## SITE PLAN REVIEW AND APPEARANCE BOARD STAFF REPORT

382 SE 2<sup>nd</sup> Avenue

Meeting	File No.	Application Type
September 28, 2022	2022-206-SPF-SPR-CL1	Class I Site Plan Modification
Property Owner	Agent	
Corey Sardoss	Mark Borg

Consideration of a Class I Site Plan Modification associated with the installation of new impact storefront windows and doors to replace existing swing doors and overhead garage doors.

## Description of Proposal

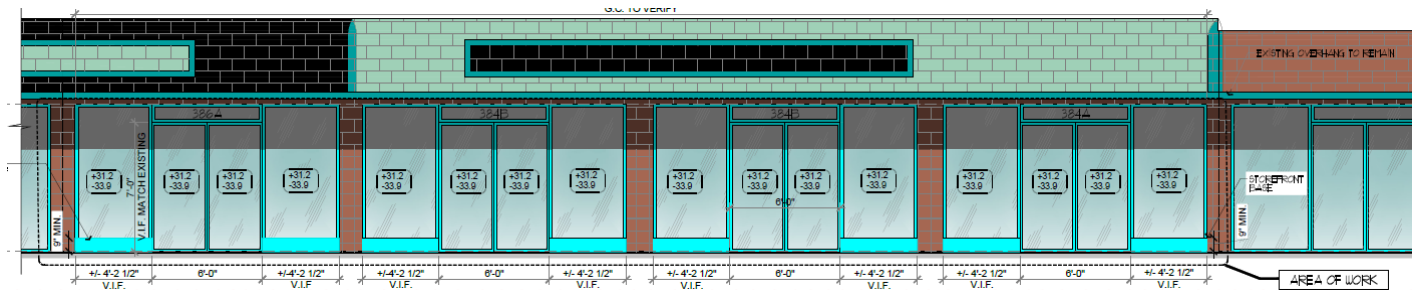
The request includes the removal of the existing swing doors, overhead garage doors and exterior concrete walls located in units 384A/B and 386A, and installation of aluminum framed storefront systems with impact glass and double door entrances. A nine-inch base is provided along the storefront windows flanking the entrances. It is important to note that there are no color changes associated with the request.

Standard/Regulation	Review
<b>Building Setback</b>	<p><b>Required:</b> Storefronts shall be directly accessible from sidewalks; storefront doors may be recessed up to ten feet.</p> <p><b>Proposed:</b> Storefronts are directly accessible from sidewalk. Setbacks are non-applicable for this proposal, due to the existing non-conforming building's setback and the proposal not altering existing setback.</p>
<b>Storefront Base</b>	<p><b>Required:</b> Storefront windows shall have a base nine inches to three feet high.</p> <p><b>Proposed:</b> The modifications include a storefront base of nine inches for Units 384A/B and 386A, which will establish consistency with the other units and reduce the existing nonconformity of the frontage type along the east elevation.</p>
<b>Glazing Height plus Storefront Base</b>	<p><b>Required:</b> Transparent glazed windows shall extend from the base to at least eight feet in height as measured from sidewalk grade adjacent to the building. Transparent means non-solar, non-mirrored, glass with a light transmission reduction of no more than 20 percent.</p> <p><b>Proposed:</b> The new storefront impact windows are eight feet in height including the nine inches from the storefront base.</p>

<b>Required Openings</b>	<p><b>Required:</b> Storefront (window and door) openings shall extend along at least 80 percent of the width of the facade of the commercial space, measured by the sum of the widths of the rough openings.</p> <p><b>Proposed:</b> The project is reducing the existing non-conformity, whereas 80 percent is not currently provided.</p>
<b>Awning Projection</b>	<p><b>Required:</b> Storefronts shall have either awnings or an arcade. Awnings shall project a minimum of five feet from the building facade.</p> <p><b>Proposed:</b> The existing building overhang, which measures approximately 24 inches to 30 inches (based on a Staff estimation), is not included in the proposed modifications and therefore, not required to meet the minimum dimension.</p>
<b>Projecting Sign</b>	<p><b>Required:</b> Projecting sign shall encroach a maximum of three feet from the building facade.</p> <p><b>Proposed:</b> Project does not propose any projecting signs. A separate request is required for any signage.</p>

Standard/Regulation	Review
<b>Appropriate Architectural Styles</b> 4.4.13(F)(3)	<p><b>Style:</b> Main Street Vernacular with Storefront Frontage Type</p> <p><b>Style Details Utilized:</b> Storefronts are generally composed of a base, one to three feet tall, with clear glazing that extends from the base to at least eight feet above the sidewalk level. Commercial windows and doors extend along at least 80% of the length of the facade of the space. The proper position of glazing on the facade ensures pedestrians are afforded a view of the merchandise and an interesting urban environment. Storefronts may incorporate arcades or awnings to provide shade and shelter.</p> <p><b>Proposed:</b> The proposed glazing height of eight feet allows potential customers to view inside the retail stores and offers an opportunity for pedestrian-retail interaction. Although, the existing facade has an opening less than 80%, the proposal reduces the non-conformity and provides shade for pedestrians with the existing overhang.</p>

Although the existing structure is non-conforming, the proposed modifications for Units 384A/B and 386A reduce the non-conformities, meet the requirements of the Storefront Frontage type and exhibit many characteristics of the Storefront style illustrated in the *Delray Beach Central Business District Architectural Design Guidelines*.

1. A note on the plan to specify and confirm compliance with the storefront requirement that the windows will be transparent, non-solar, non-mirrored, glass with a light transmission reduction of no more than 20 percent.
